From: Clerks@vaughan.ca
Subject: COW Report #30, Item # 5 (June 17, 2014 COW) - - Portside Developments (Kipling) Inc. 7476 Kipling Avenue Vaughan
Attachments: 7476 Kipling Planning Addendum Report May 29 2014.pdf; 7476 Kipling_Revised Plans.pdf; VAWood Attachments.pdf

PLANNING ADDENDUM REPORT RE 7476 KIPLING AVENUE, CITY OF VAUGHAN

OFFICIAL PLAN AMENDMENT FILE OP.13.003, ZONING BY-LAW AMENDMENT FILE Z.13.005

Re: Ref. No. 6109-12-7
Slope Assessment
7476 Kipling Avenue
Vaughan, Ontario

EROSION HAZARD LIMIT ON PROPOSED SITE PLAN

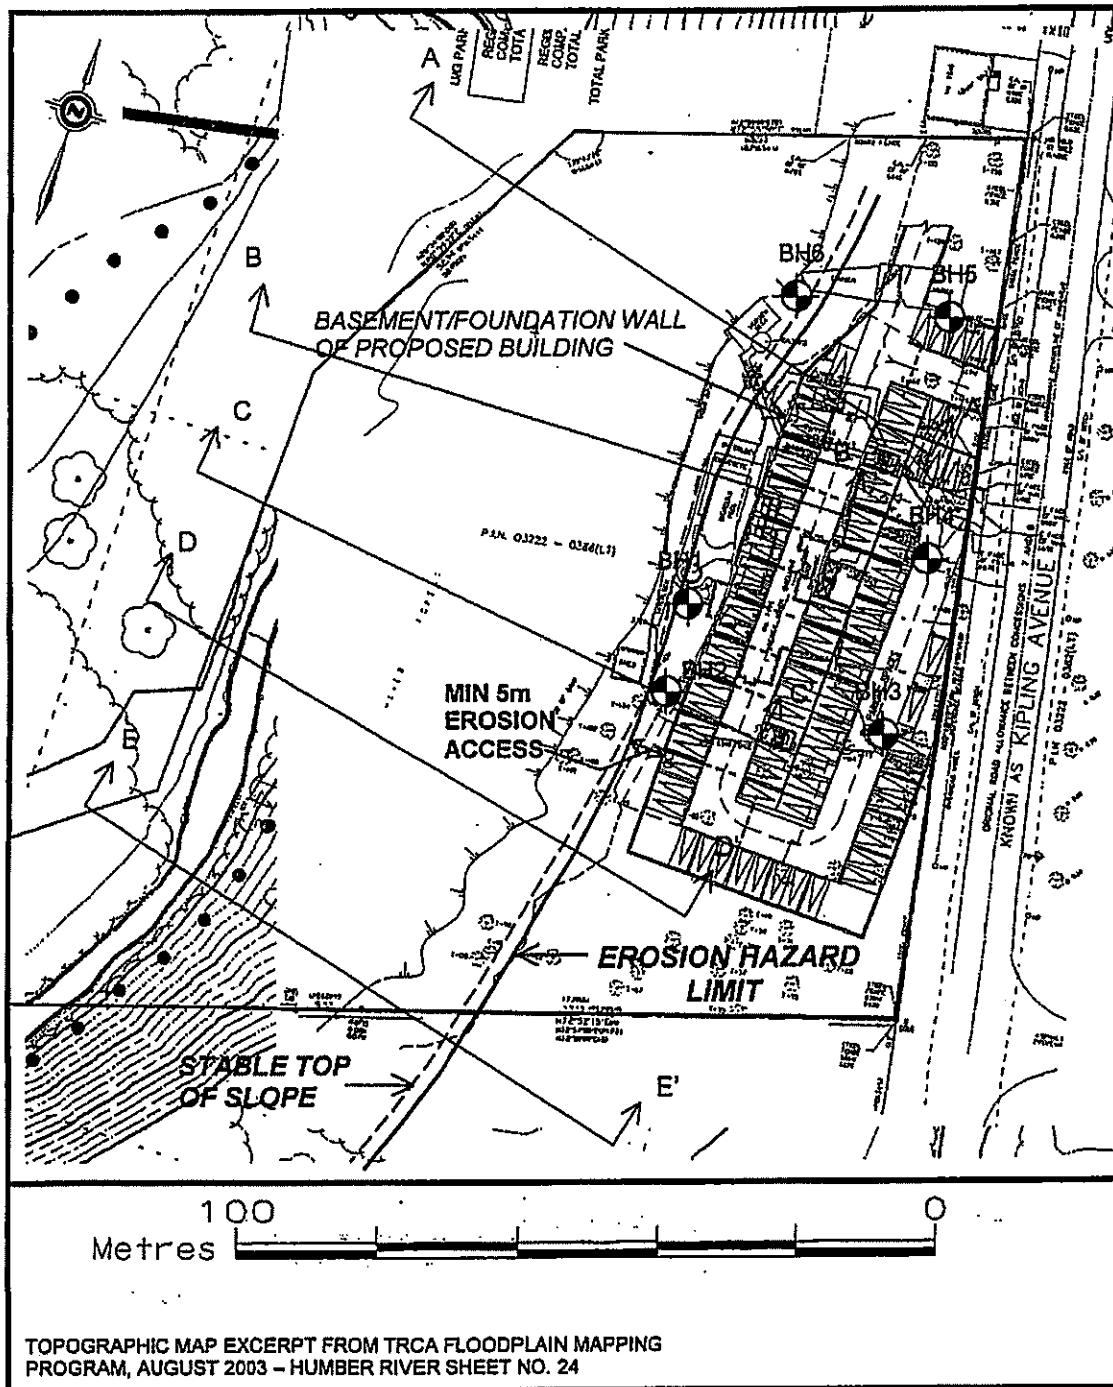
Line is shown on plan in Enclosures 15 and 16 of the geotechnical report. The TRCA requires that the Erosion Hazard Limit Line be shown on Drawing A102 (Site Plan) plus the required setback/buffer.

- The Erosion Hazard Limit should then be plotted on a Site Plan.
